**VILLAGE OF WESTMONT
PLANNING AND ZONING COMMISSION
AGENDA ITEM**

P/Z 16-019

TITLE: Peak Custom Homes LLC regarding the properties located at 224 and 226 West Burlington Avenue, Westmont, IL 60559 for the following:

Re: Preliminary Land Development, Stormwater & BMP Review – Site Improvement Plans for 224-226 Burlington Avenue

LANDSCAPE PLAN

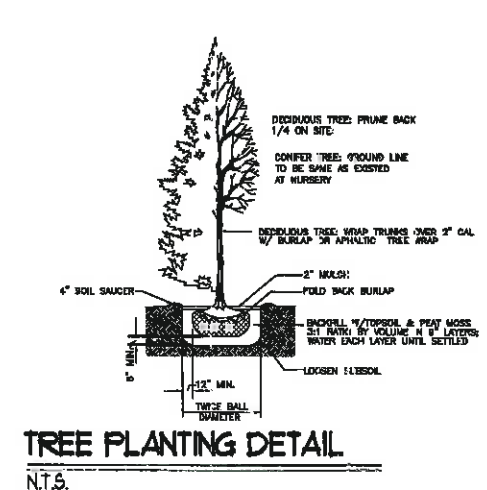
1. *If it appears that existing trees on the property will be impacted by the proposed development. A tree survey will be required. (See notes/comments from previous section.)*
2. *The plant list is incorrect. Periwinkle ground cover as noted on the site plan is not listed or quantities shown.*
3. *The landscape plan is missing the utility easements and proposed contours.*
4. *The required landscape calculations to meet the Village requirements are as follows:*

There is a total of 232 LF of building foundation depicted on the plan. There is 98 LF of building foundation facing a public and private street.

The required plantings are 10 shrubs. There is a total of 19 that are provided along the front and rear yard. Requirement has been met.

There is a total of 49 LF of building foundation along the front yard. There are no corner side yards on the site. The required planting is 1 shade trees. There is a total of 1 shade tree provided. Requirement has been met.

There is a total of 49 LF of building foundation along the front yard. There are no corner side yards on the site. The required planting are 2 ornamental trees. There is a total of 2 ornamental trees provided. Requirement has been met.

There is a total of 49 LF of building foundation along the front yard. There are no corner side yards on the site. The required planting are 2 evergreen trees. There is a total of 2 evergreen trees provided. Requirement has been met.

Periwinkle ground cover and mulch beds have been noted. Requirement has been met.

FRONT ELEVATION

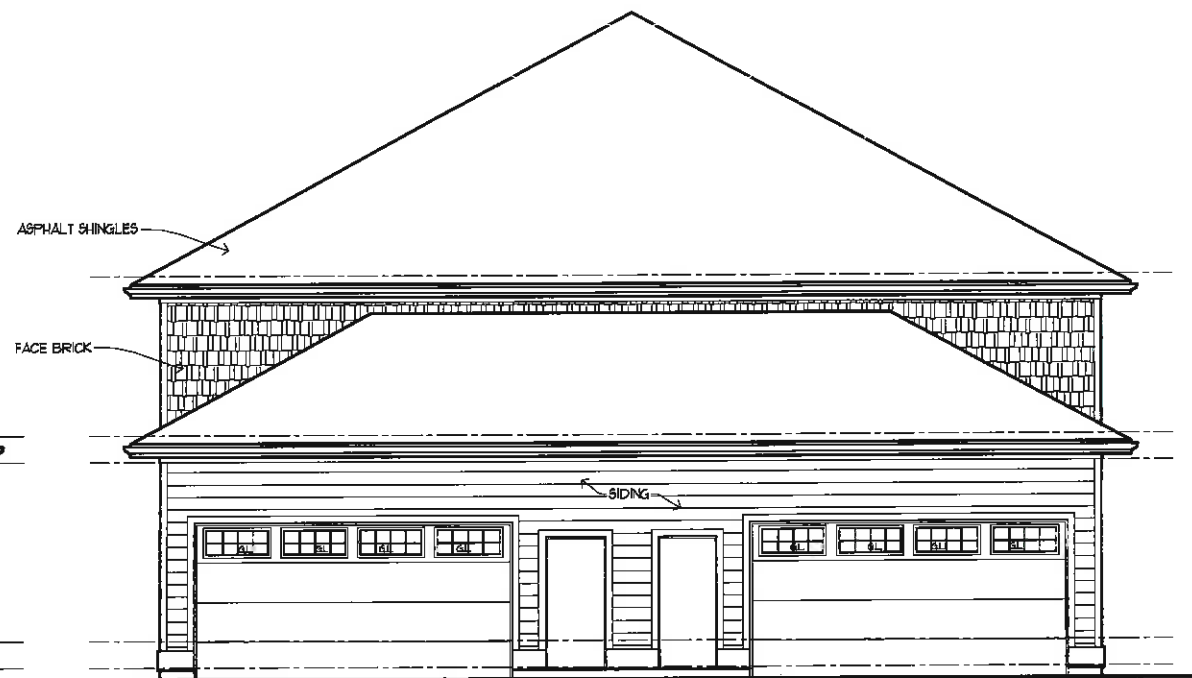
No changes have been made to the original staff report from August. At the August hearing, both variance requests received positive recommendations, and the site and landscaping plan approval was postponed in order for the front facade of the building to be revised with architectural improvements. Although the applicant has submitted revised renderings, staff has asked for additional revisions, which will be provided after the date of this staff report. A preliminary draft of the revised elevation has been included to show progress.
